Form 3160-5
(June 2019)UNITED STATES
DEPARTMENT OF THE INTERIOR
BUREAU OF LAND MANAGEMENTFORM APPROVED
OMB No. 1004-0137
Expires: October 31, 2021**SUNDRY NOTICES AND REPORTS ON WELLS**
Do not use this form for proposals to drill or to re-enter an abandoned well. Use Form 3160-3 (APD) for such proposals.5. Lease Serial No. **NMNM110835**

8. Well Name and No. **RESOLUTE 12 FED COM/508H**9. API Well No. **3002547603**10. Field and Pool or Exploratory Area
WC-025 G-09 S253309P; Upper Wolfcamp11. Country or Parish, State
LEA/NM**12. CHECK THE APPROPRIATE BOX(ES) TO INDICATE NATURE OF NOTICE, REPORT OR OTHER DATA**

EOG respectfully requests an amendment to our approved APD for this well to reflect the following changes:

**Resolute 12 Fed Com 752H****Revised Permit Information 03/04/2022:**

WELL LOCATION AND ACREAGE DEDICATION PLAT

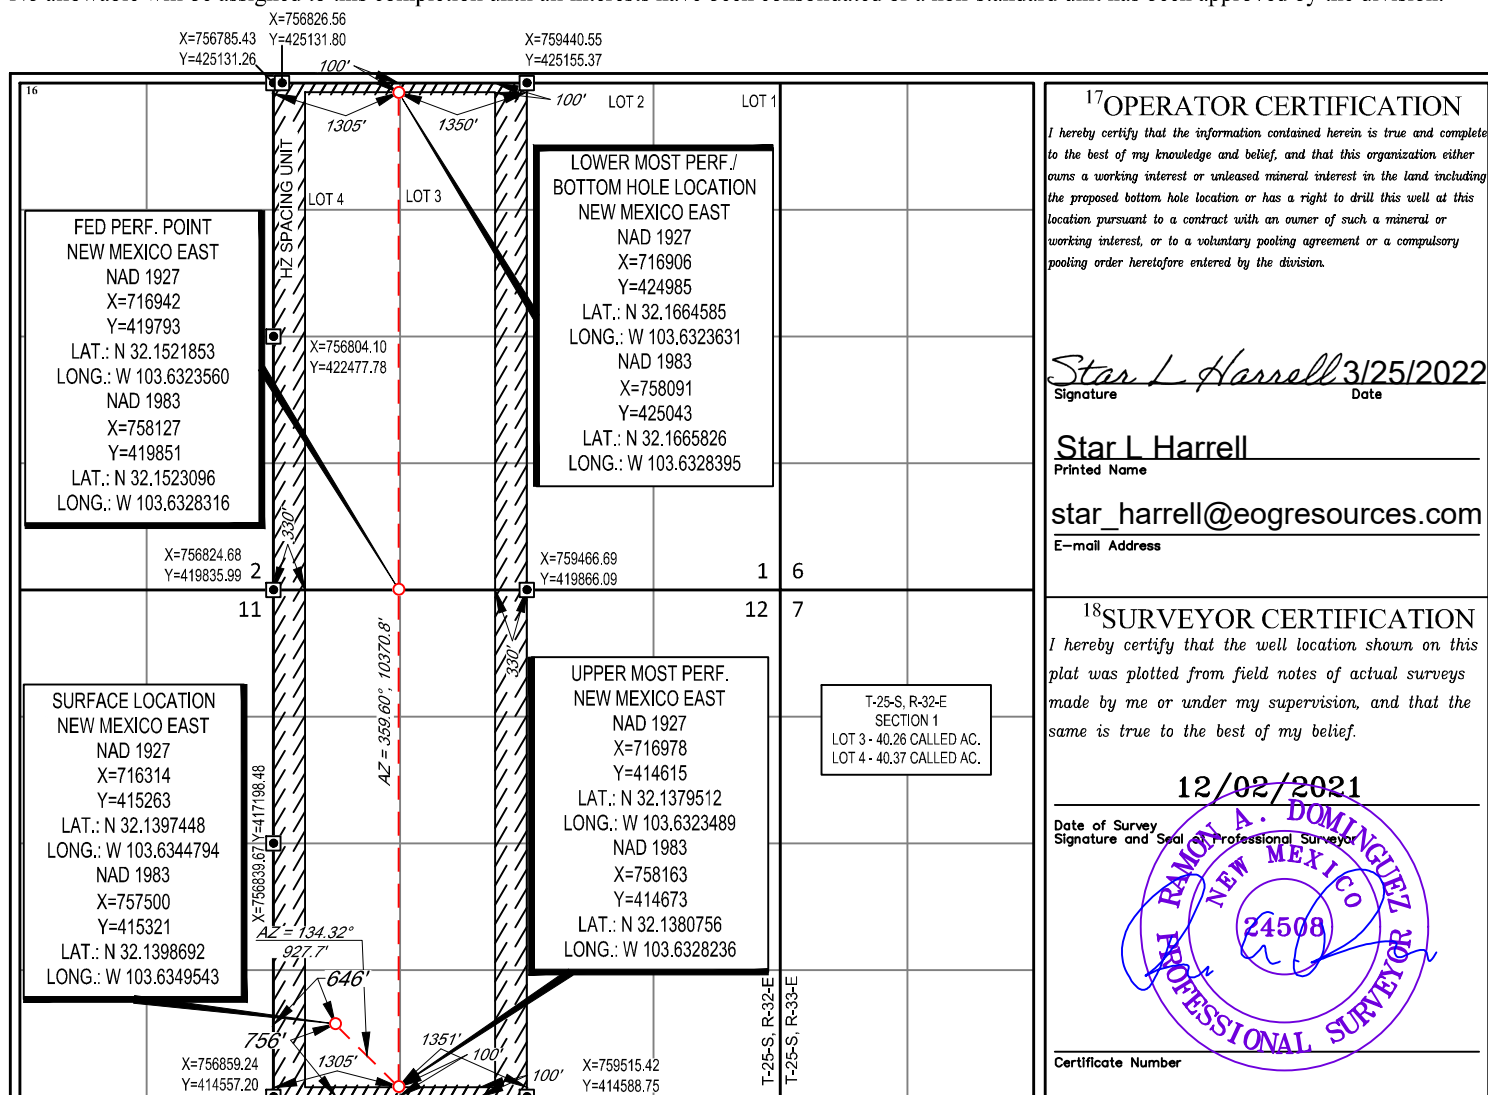
Change name from 508H to Resolute 12 Fed Com 752H.

Change SHL from T-25-S, R-32-E, Sec 12, 344' FSL, 1505' FEL, Lea Co., NM, to T-25-S, R-32-E, Sec 12, 756' FSL, 646' FWL, Lea Co., N.M.

Change BHL from T-25-S, R-32-E, Sec 1, 100' FNL, 1338' FEL, Lea Co., NM, to T-25-S, R-32-E, Sec 1, 100' FNL, 1305' FWL, Lea Co., N.M.

UL or lot no.	Section	Township	Range	Lot Idn	Feet from the	North/South line	Feet from the	East/West line	County
M	12	25-S	32-E	-	756'	SOUTH	646'	WEST	LEA

UL or lot no.	Section	Township	Range	Lot Idn	Feet from the	North/South line	Feet from the	East/West line	County
3	1	25-S	32-E	-	100'	NORTH	1305'	WEST	LEA

Revised Wellbore

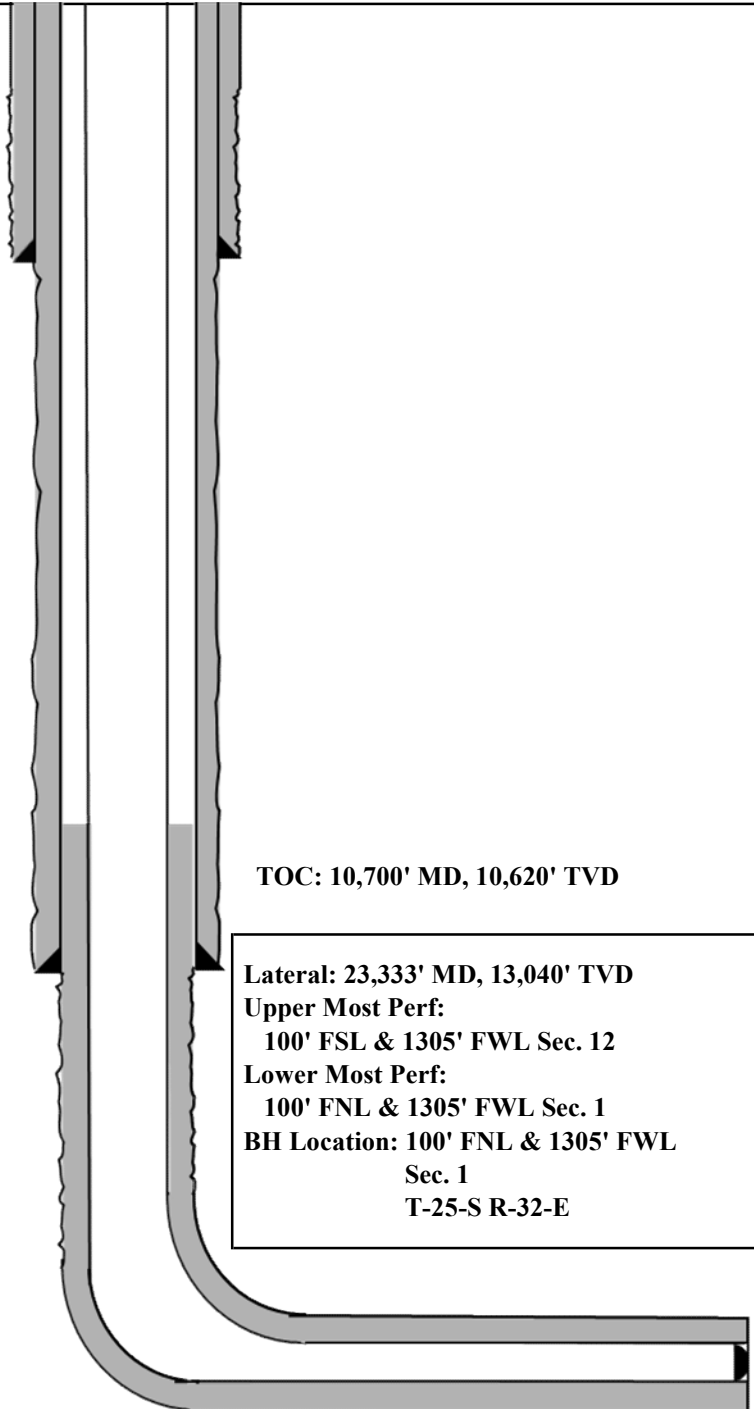
Update casing and cement program to current design.

Bit Size: 12-1/4"
9-5/8", 36#, J-55, LTC,
@ 0' - 1,070'

Bit Size: 8-3/4"
7-5/8", 29.7#, HCP-110, FXL,
@ 0' - 11,200'

Bit Size: 6-3/4"
5-1/2", 20#, P110-EC, DWC/C IS MS,
@ 0' - 10,700'
5-1/2", 20#, P110-EC, Vam Sprint SF,
@ 10,700' - 11,200'
5-1/2", 20#, P110-EC, DWC/C IS MS,
@ 11,200' - 23,333'

KOP: 12,640' MD, 12,562' TVD
EOC: 13,390' MD, 13,040' TVD

Proposed Wellbore

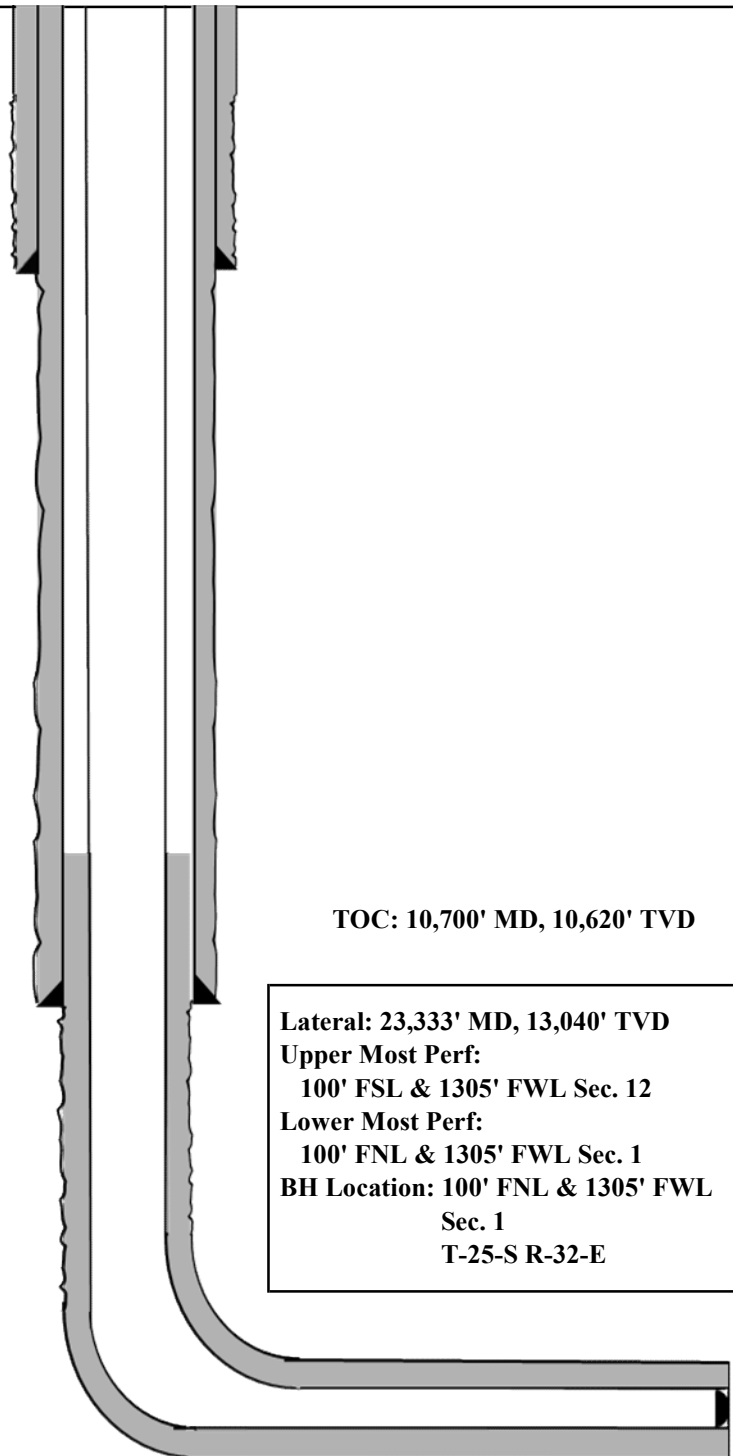
Design B**4. CASING PROGRAM**

Bit Size: 13"
10-3/4", 40.5#, J-55, STC,
@ 0' - 1,070'

Bit Size: 9-7/8"
8-3/4" 38.5#, P110-EC, Vam Sprint-SF,
@ 0' - 11,200'

Bit Size: 7-7/8"
6", 24#, P110-HP, Eagle SFH SC,
@ 0' - 23,333'

KOP: 12,640' MD, 12,562' TVD
EOC: 13,390' MD, 13,040' TVD

TOC: 10,700' MD, 10,620' TVD

Lateral: 23,333' MD, 13,040' TVD
Upper Most Perf:
100' FSL & 1305' FWL Sec. 12
Lower Most Perf:
100' FNL & 1305' FWL Sec. 1
BH Location: 100' FNL & 1305' FWL
Sec. 1
T-25-S R-32-E
